SUBJECT: U.S. NUCLEAR REGULATORY COMMISSION REVIEW OF THE PROPOSED REVISION 6 TO THE NUCLEAR ENERGY INSTITUTE (NEI) NEI 99-01, "DEVELOPMENT OF EMERGENCY ACTION LEVELS FOR NON-PASSIVE REACTORS," DATED SEPTEMBER 2012

Enclosure 1
NRC Staff Questions and Comments

Enclosure 2

Figure 9-F-4 Consideration

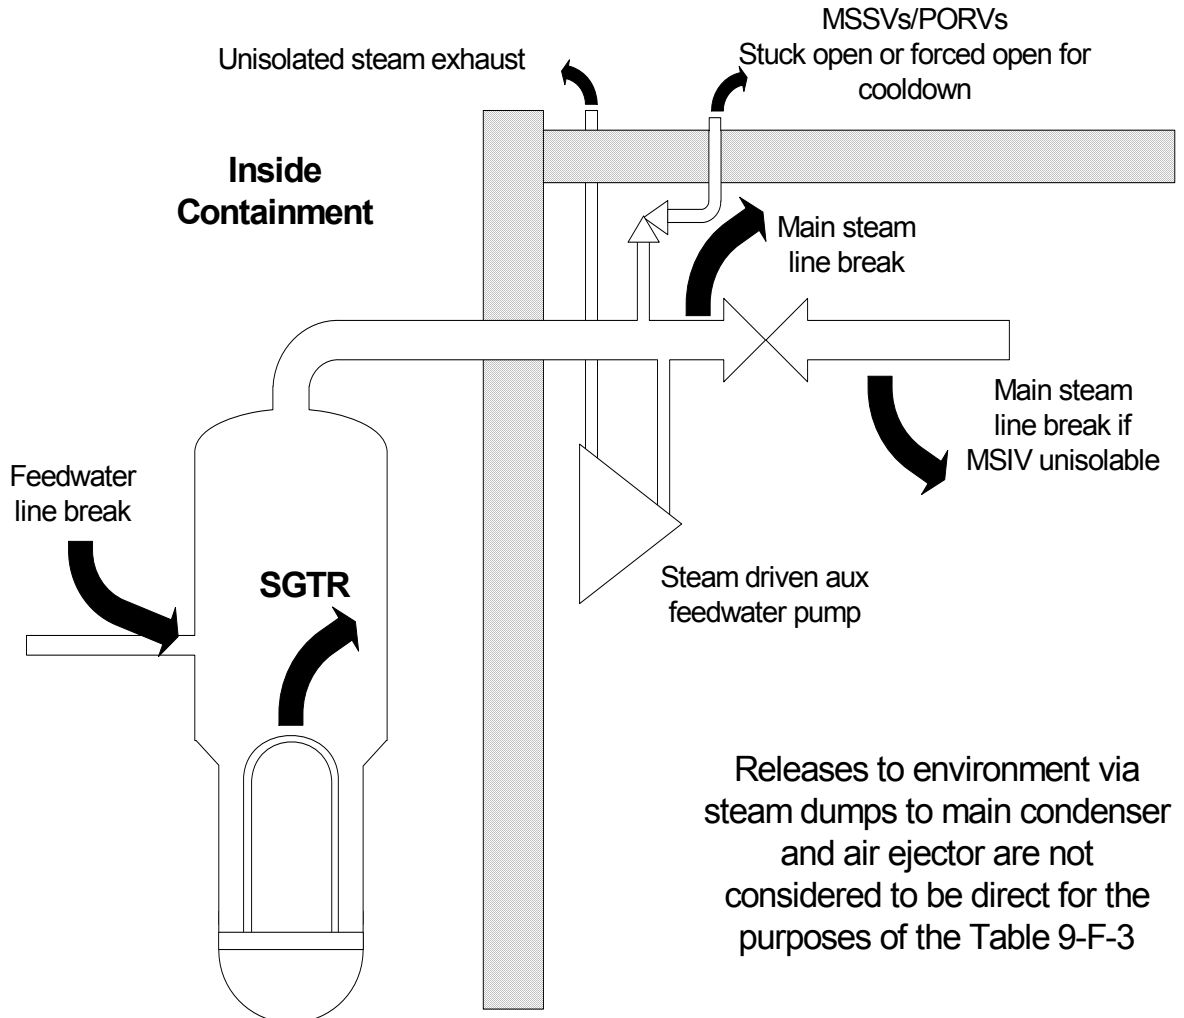
- b. PWR Containment Barrier Loss 4A.1: Please add the following to the developer notes: *"A failed feedwater line to a steam generator inside containment, in conjunction with a FAULTED steam generator, would also create an UNISOLABLE pathway since the steam generator would be dry."*

- f. Please consider adding the drawing in Enclosure 2 to Figure 9-F-4.
6. EAL HU2: The staff recommends two distinct approaches to this EAL.
- a. Approach #1, which is the staff's preference, is for licensees that have an alarm in the Control Room at the operating basis earthquake (OBE) level. In this case, the only EAL is the occurrence of this alarm.

A feedwater line break inside containment would blowdown the steam generator and provide a path for the containment atmosphere to be released via the FAULTED steam generator (SG).

If the main condenser is unavailable (e.g., loss of offsite AC power) plant cooldown would be affected by dumping steam to the atmosphere. Although this is directed by procedures, it creates a bypass of containment when occurring in conjunction with a steam generator tube rupture (SGTR) or a feedwater line break.
